Addendum No. M-03

Reference: Added Scope and clarification

Issue Date: November 12, 2024

Project: UHN TWH – SEM & Corridor (EXP Project Number MRK-23004289-A0)

DRAWING NO:
M-211B

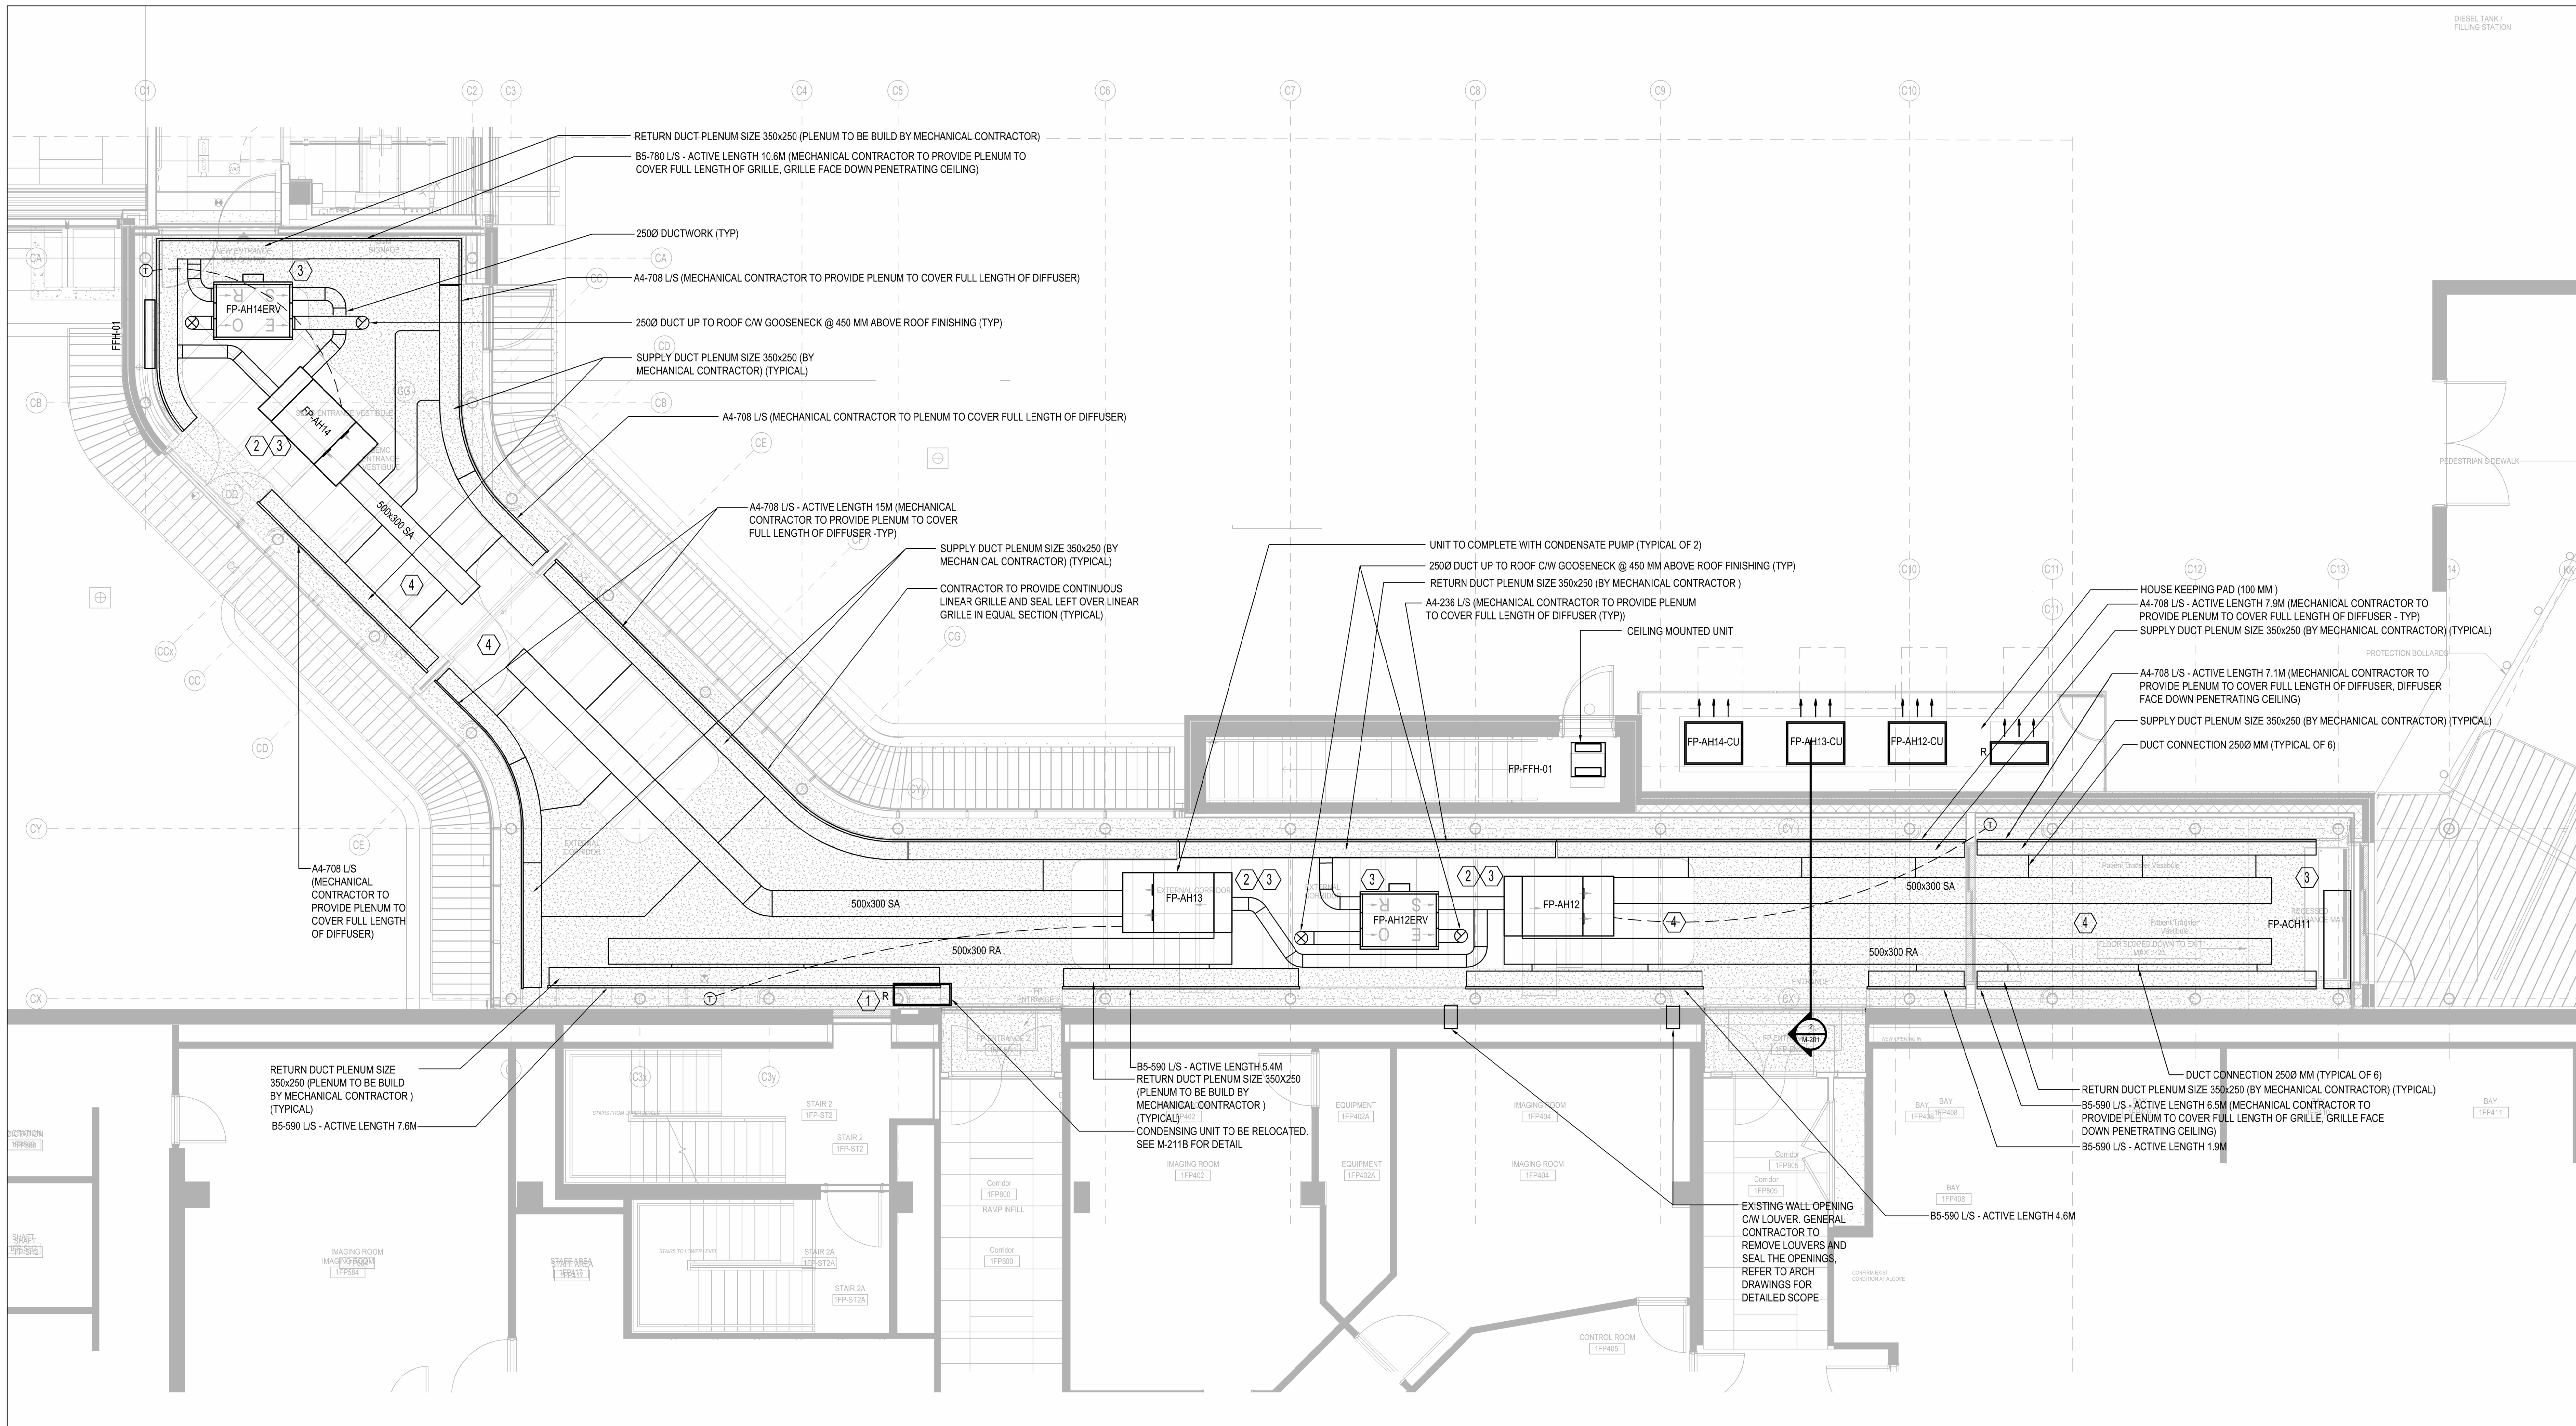
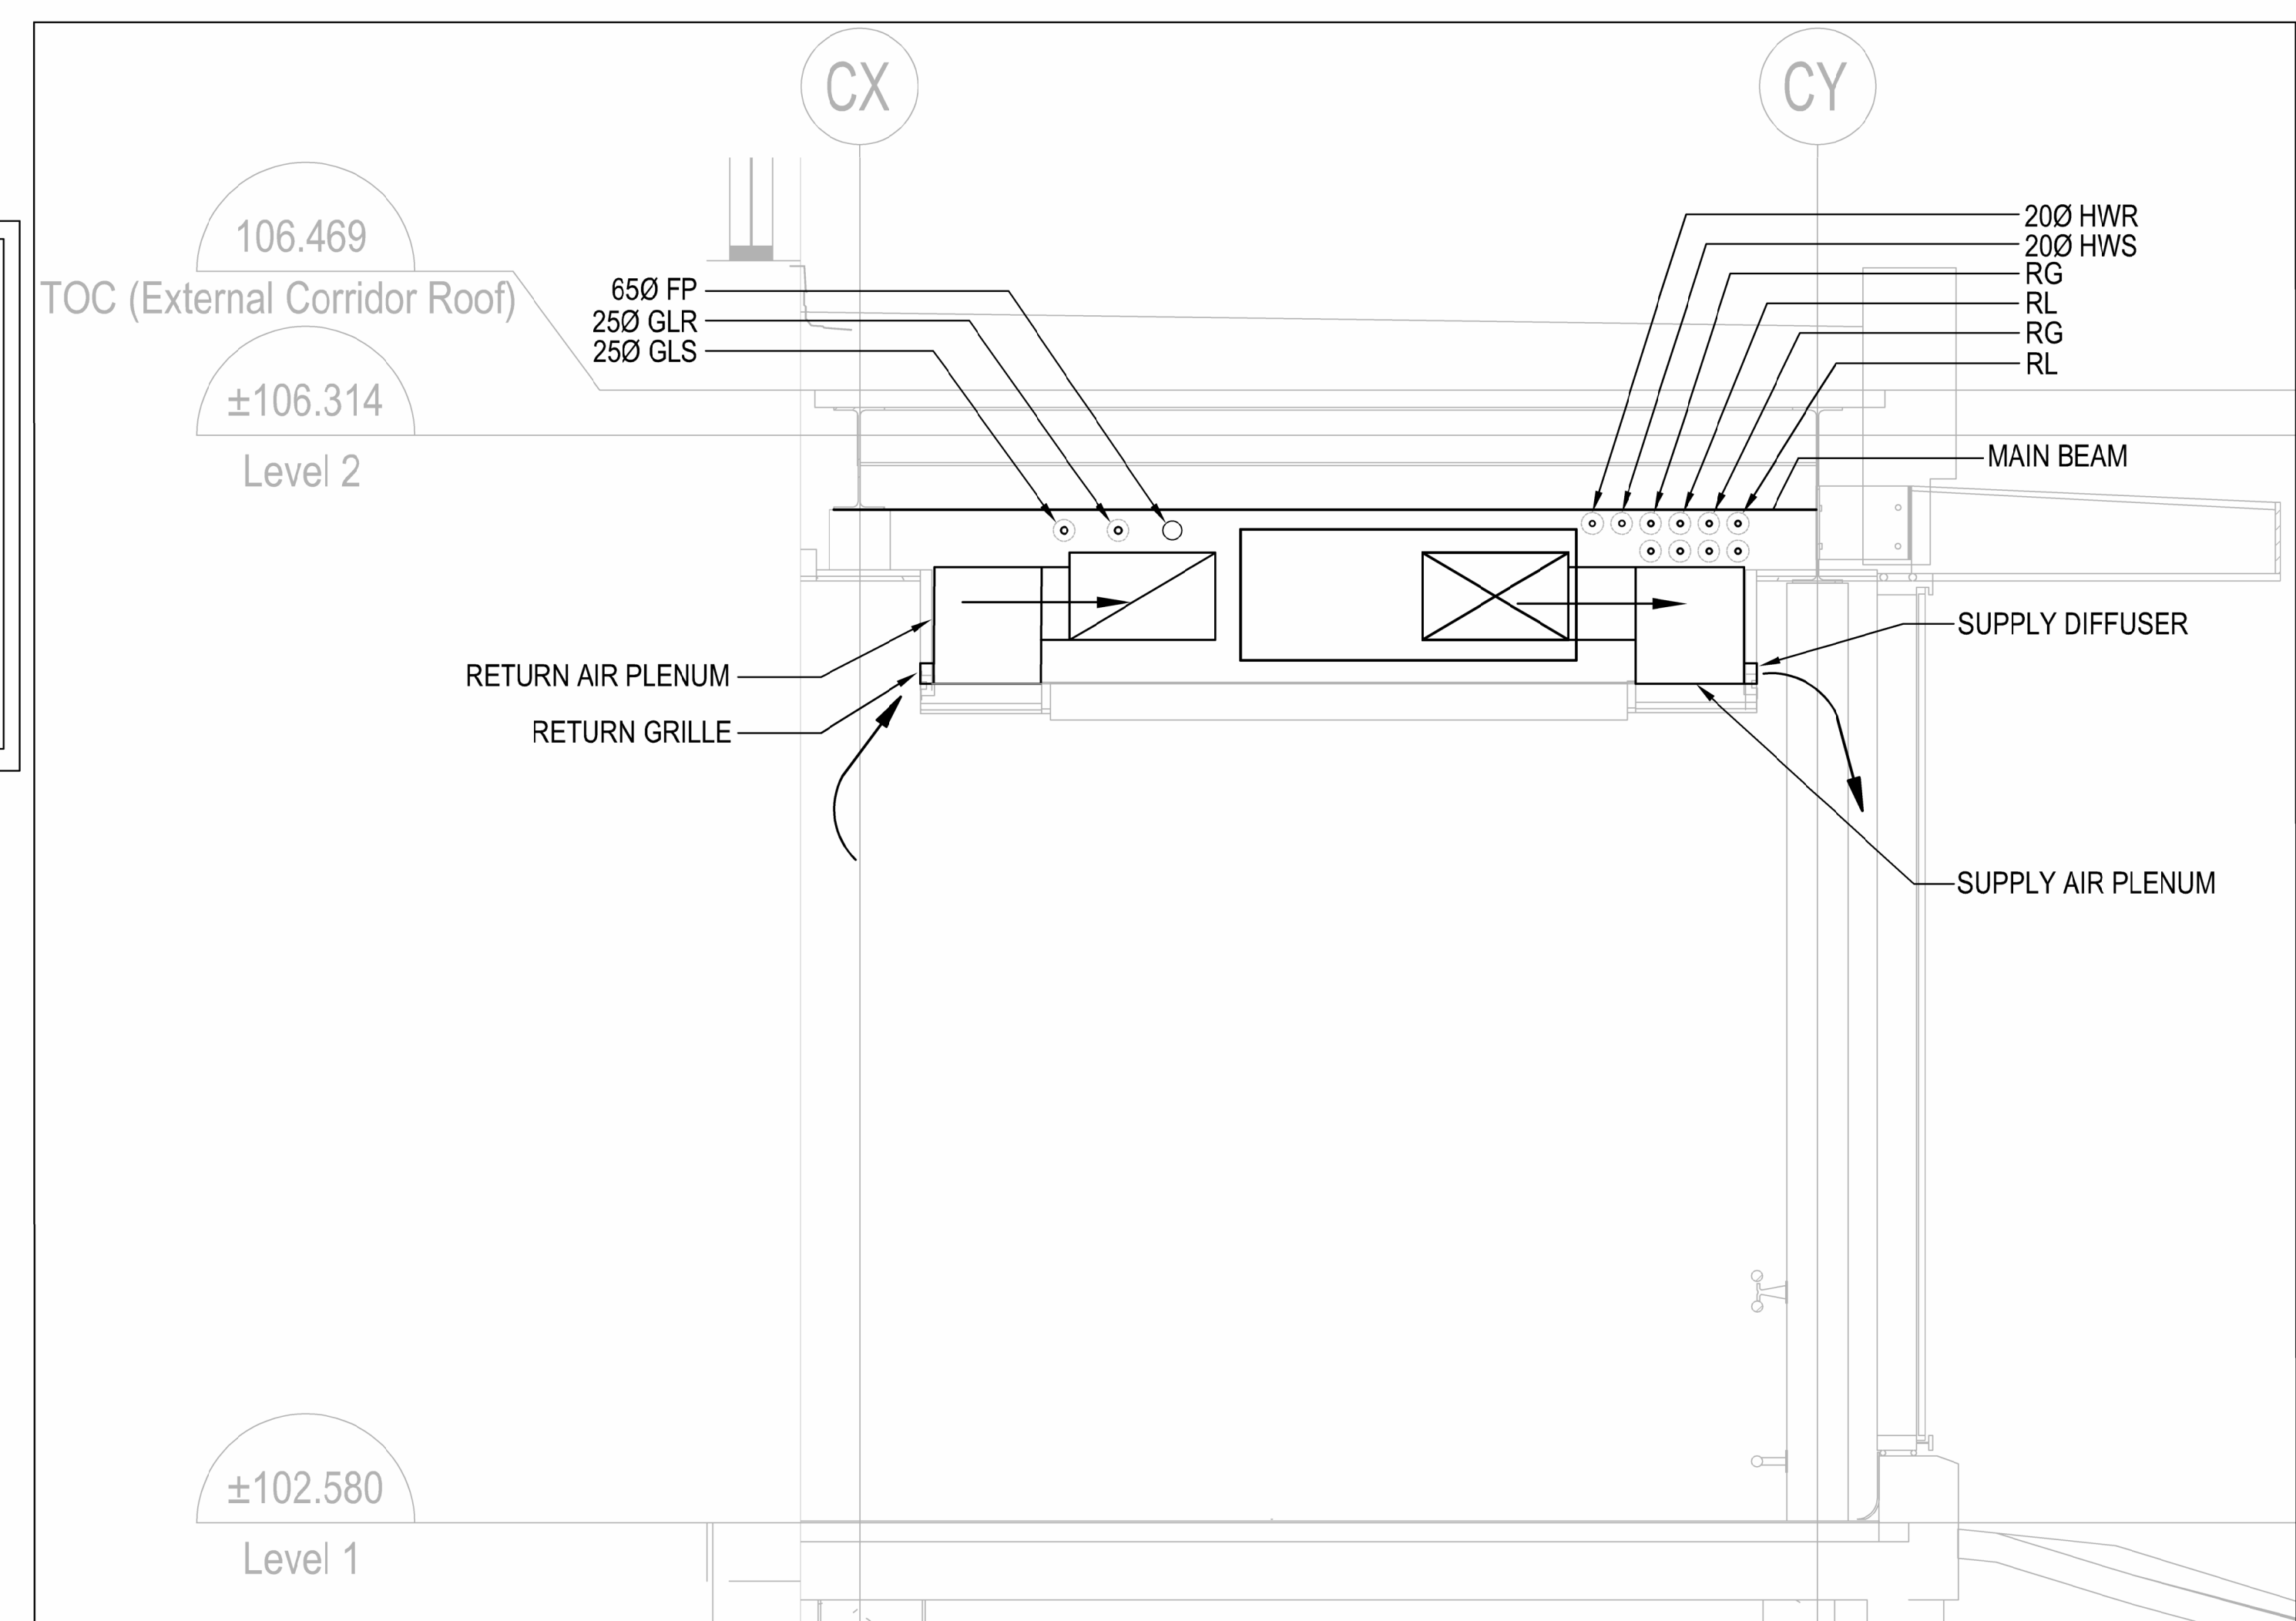
- 1.1.9. **M-211A - LEVEL 1 FLOOR PLAN - NEW WORK -VENTILATION**
 - .1 Revised as shown.
- 1.1.10. **M-301 - LEVEL 1 FLOOR PLAN - DEMO – HVAC PIPING**
 - .1 Revised as shown.

PROJECT NO.: MRK-23004289
DRAWING NO.: M-311A
CHECKED: S.S.

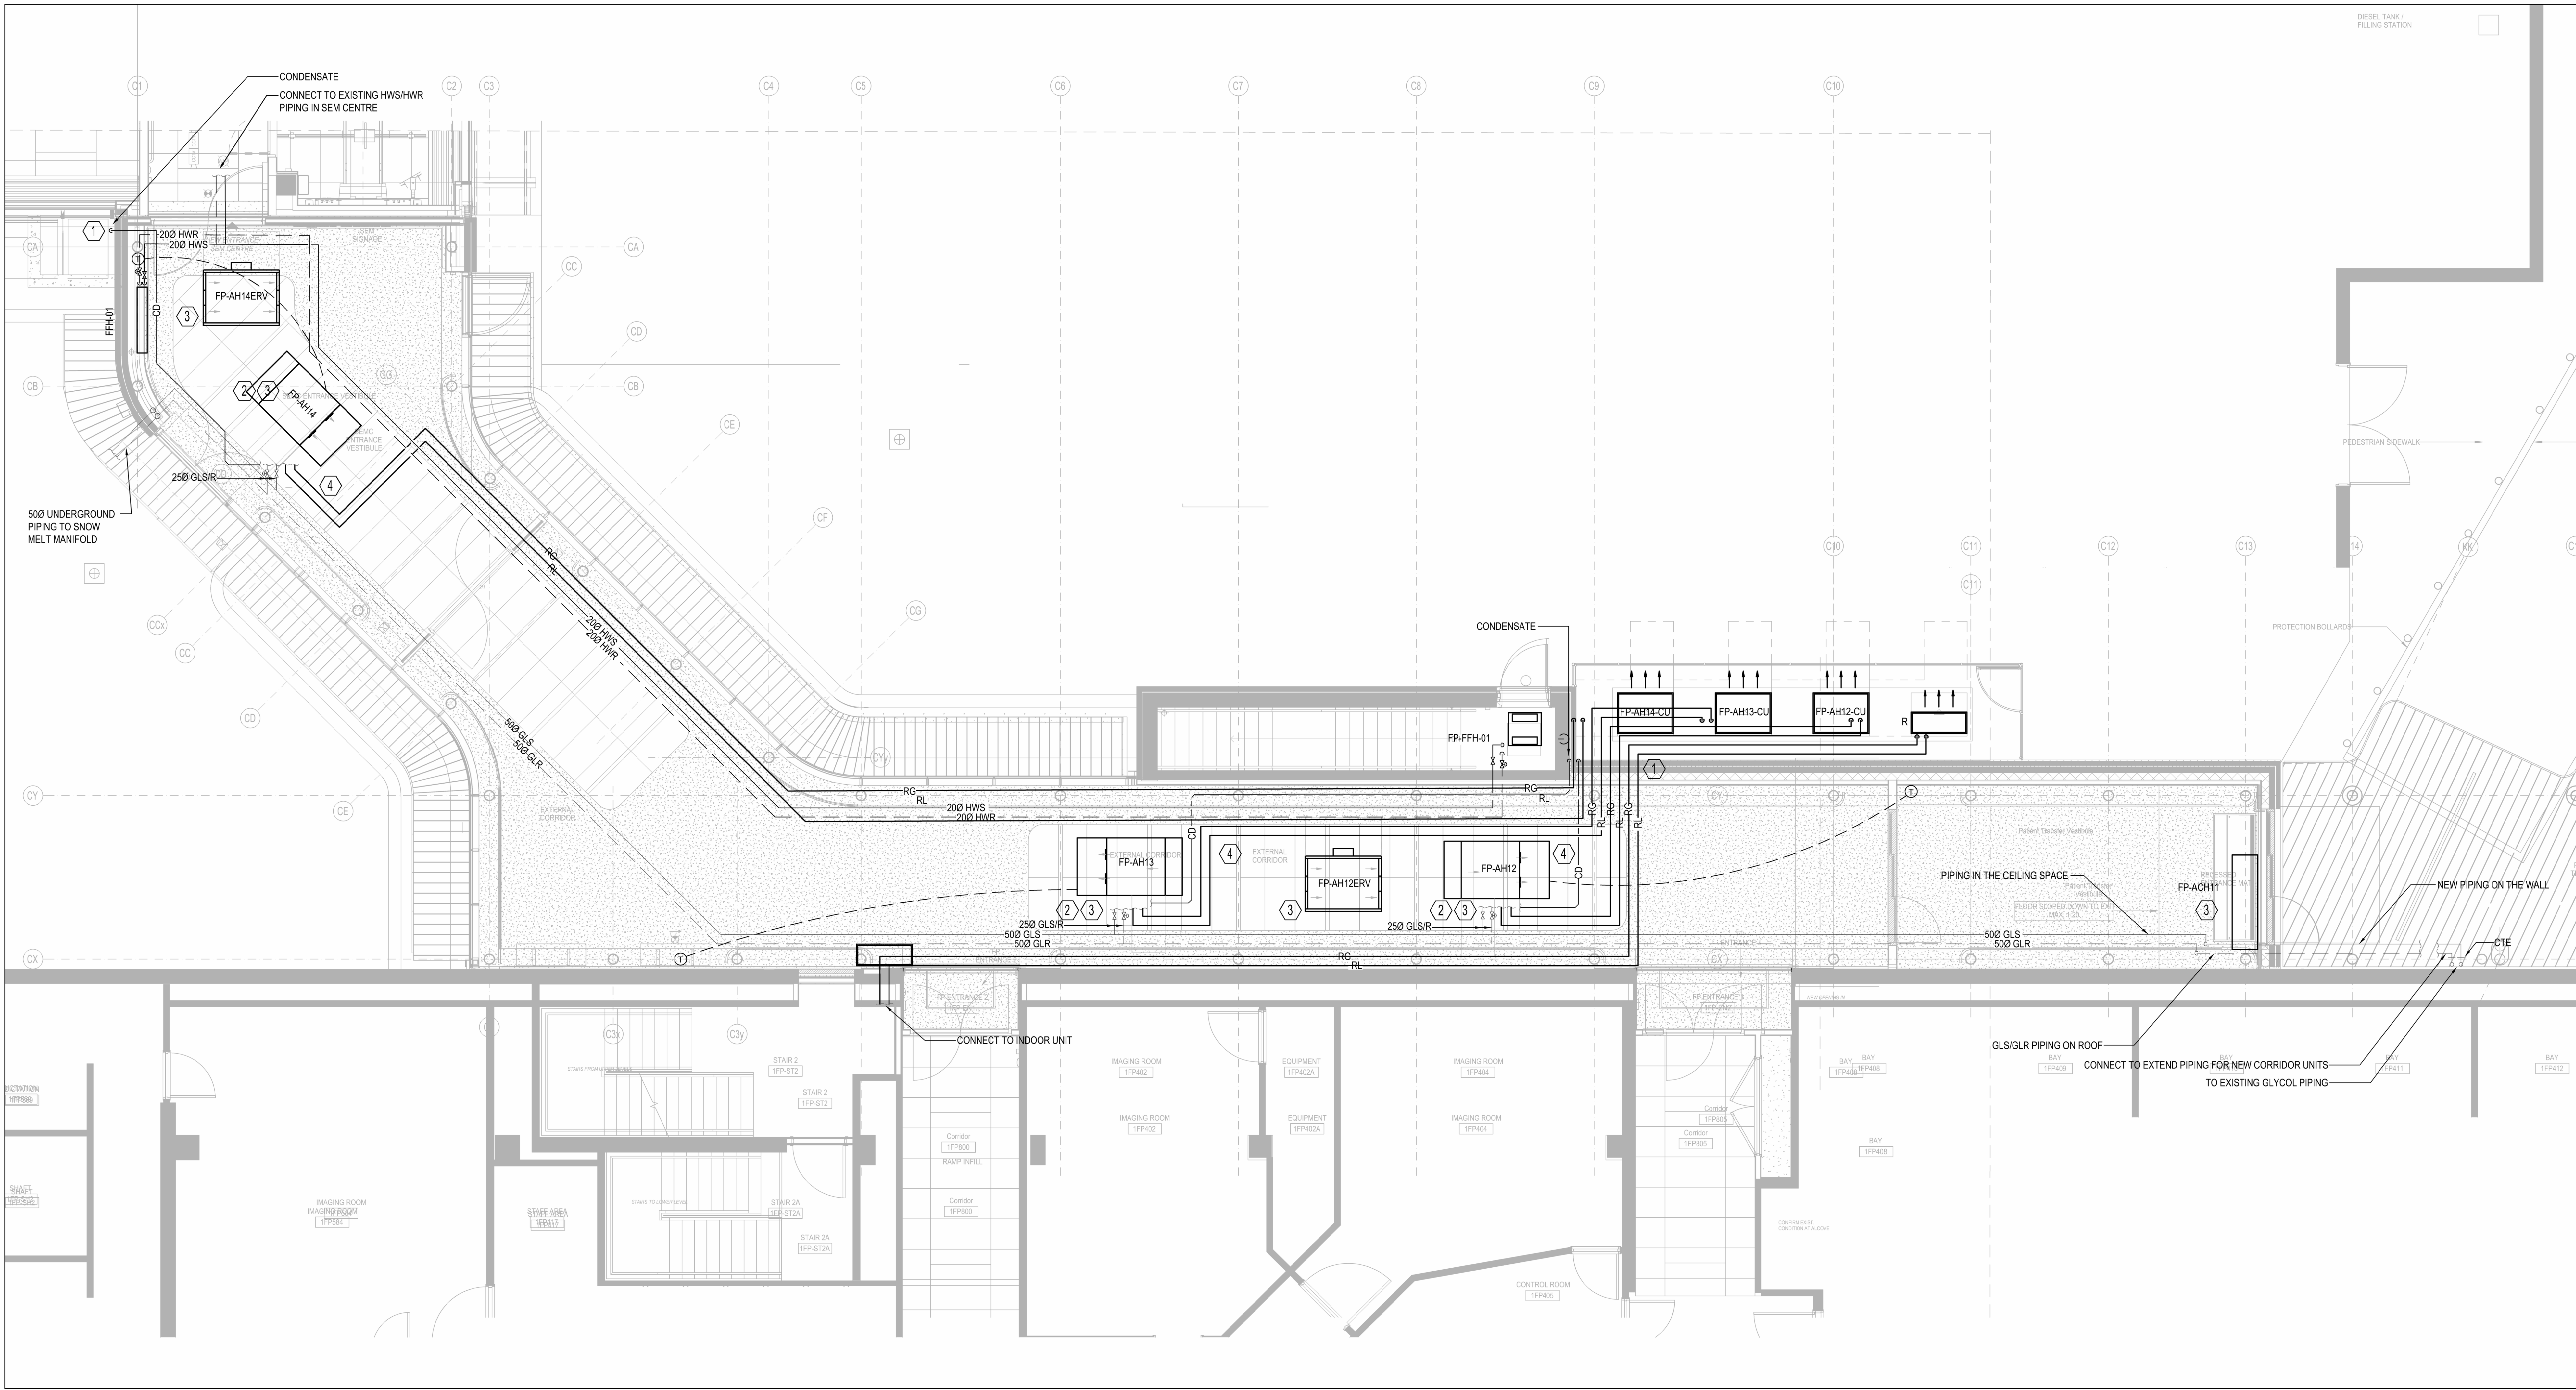
- 1.1.11. **M-311A - LEVEL 1 FLOOR PLAN - NEW WORK – HVAC PIPING**
 - .1 Revised as shown.
- 1.1.12. **M-313 - PENTHOUSE & ROOF FLOOR PLAN – NEW WORK – HVAC**
